ADDRESS OF PROPERTY: 328 E Worthington Av, Dilworth Local Historic District HDC 2013-012

**SUMMARY OF REQUEST:** Rear Addition

For submission to DHC Certificate of Appropriateness

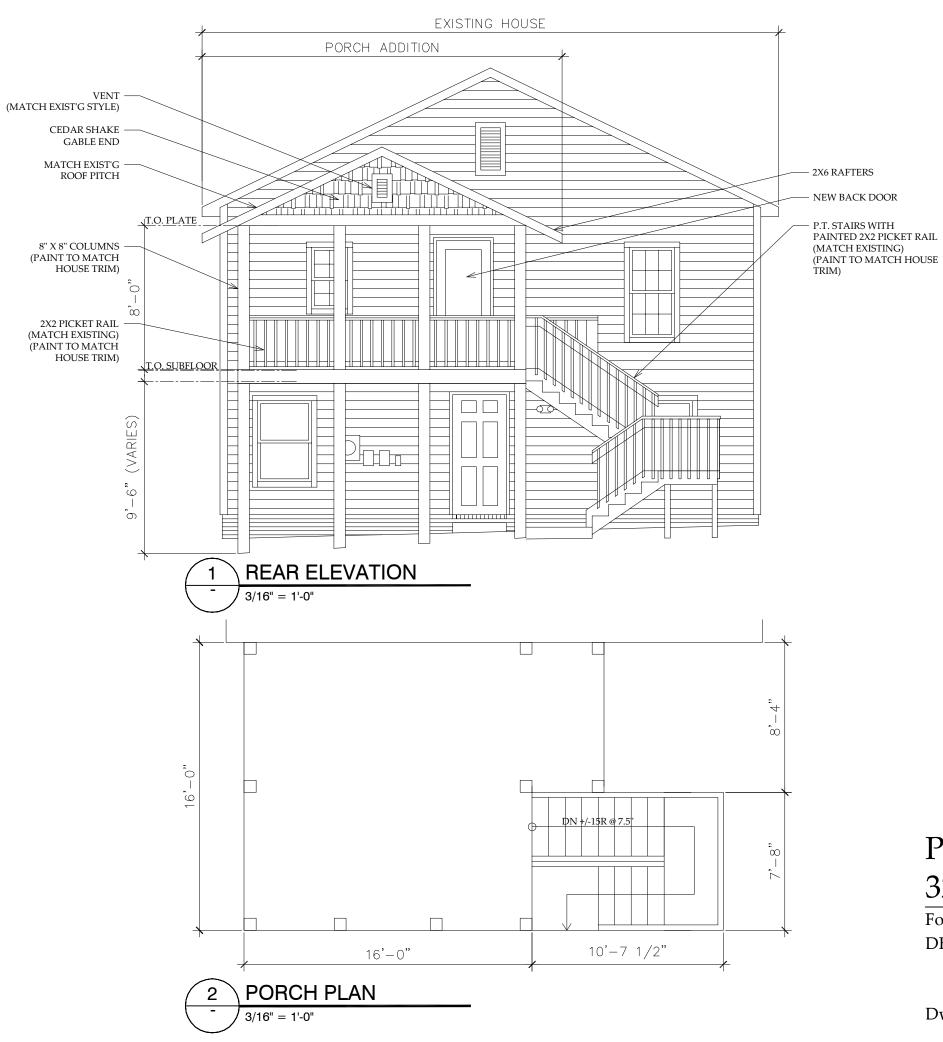
The proposed porch structure is projected from the finished floor level of the house, which is significantly higher than the rear grade of the house. The porch is an open deck under a projecting rear-facing gable that is of the same slope and proportions as the main gabled roof of the house. The deck is supported by a series of 8x8 posts, matching both the ones above and the existing ones on the front porch of the house. There is a staircase leading from the deck level to the ground on the street side of the structure, with a center landing. Also as part of this proposal, a new rear door would be installed to access the deck from the house.

Overall, this proposal appears to meet these guidelines.

The overall design of the addition is in proper proportion to the house. Also, site conditions seem to preclude the relocation of the proposed stairs to the inward side of the deck away from Euclid Avenue.

The only overall improvement under the guidelines would be in detailing this rear addition more in keeping with the front porch rather than like a rear yard desk, due to its visual prominence.
